City of Santa Clara

Historical & Landmarks Commission

Thursday, May 2, 2024

2. 24-370 [PUBLIC HEARING: Consideration of a Significant Property Alteration Permit \(PLN24-00062\) for a 266 Square-Foot Addition to a Historic Resource Inventory Property at 1176 Lincoln Street](#)

PROPOSED FRONT ELEVATION

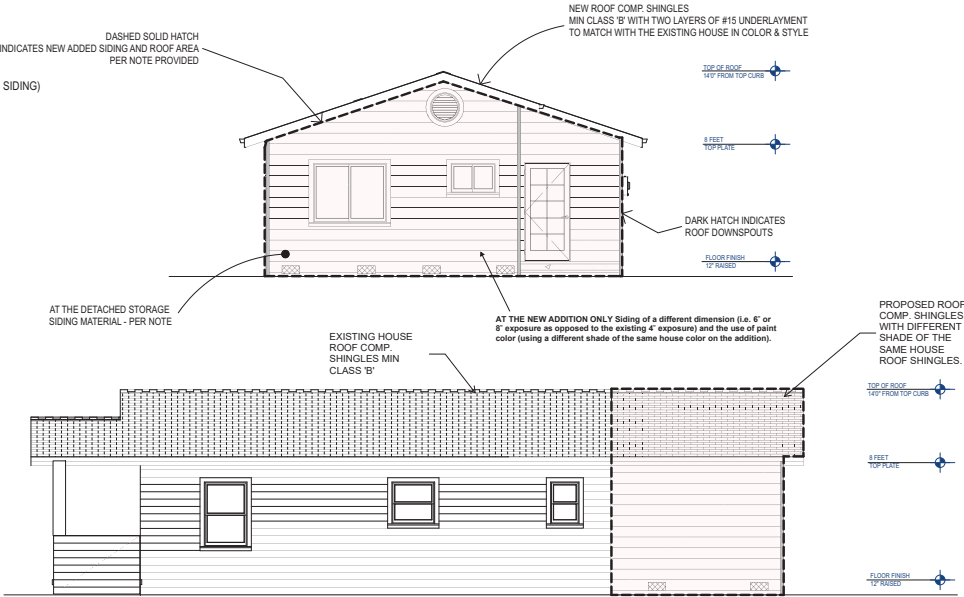
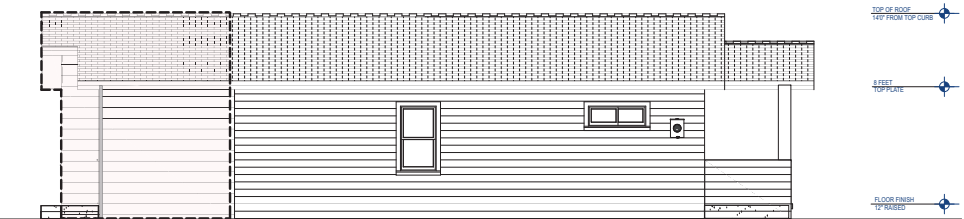
Several items of concern that are not detailed on the plans are as follows:

- *The new siding material and exposure should be specified on the plans. We have assumed that it is redwood or cedar beveled siding similar to the existing.*
- *The connection of the exterior walls between the new and old siding should be detailed. It will probably be offset by ½" which should be covered by a notched wood trim.*
- *The installation of any under-siding structural sheathing for the new construction as it affects the wall thickness (relates to the items above).*

The structural plans indicate installation of StrongWall panels for lateral resistance. Those panels are 4" thick which exceeds the wall stud thickness of 3.5" and must be accommodated somehow (not now shown on the plans). The proper SW footings are also not properly shown. If any of these issues affect the exterior appearance of the building, another historic review should be done.
